NOTICE TO ALL CONTRACTORS:

Proposal #14: 1053-07-60
Wausau - Wittenberg
CTH D to CTH OO
STH 29
Marathon County

This is Addendum No. 01, which provides for the following:

ADDENDUM NO. 01

Addendum No. 01
ID 1053-07-60
Revised Sheet 19
August 7, 2025

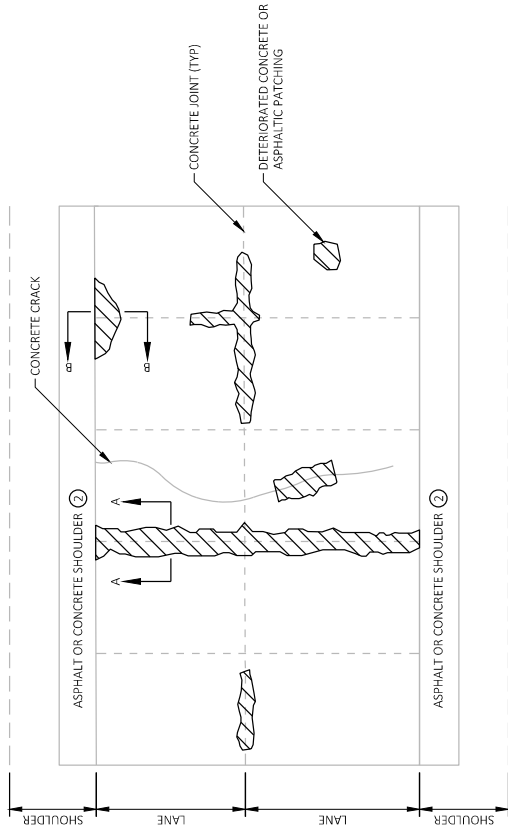
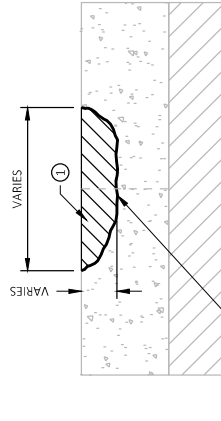
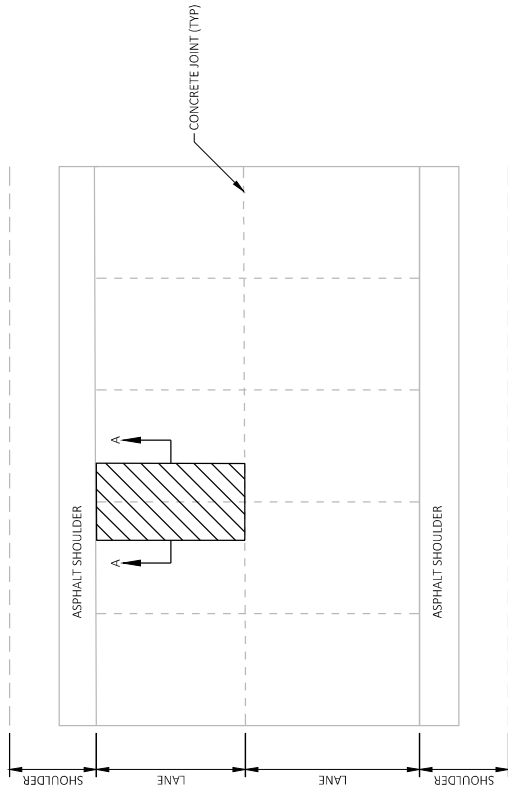
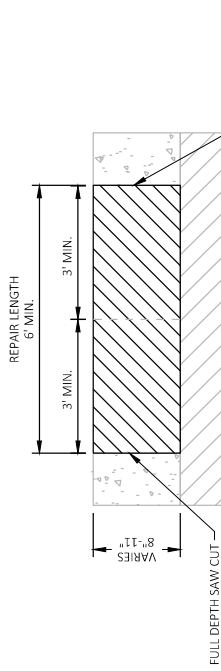
Revised Plan Sheets	
Plan Sheet	Plan Sheet Title (brief description of changes to sheet)
10	Typical Section (revised STA 1173'EB'+13 – STA 1193'EB'+75 and STA 1193'EB'+75 – STA 1223'EB'+54)
19	Construction Details (revised detail sub-title)
62	Miscellaneous Quantities (revised 305.0500, 624.0100, and SPV.0060.04)
63	Miscellaneous Quantities (revised 211.0500, 305.0120 and SPV.0090.01, surface drain title)

CONCRETE JOINT AND CRACK CLEANING AND REPAIR
LOCATIONS AND LIMITS DETERMINED BY THE ENGINEER IN THE FIELD
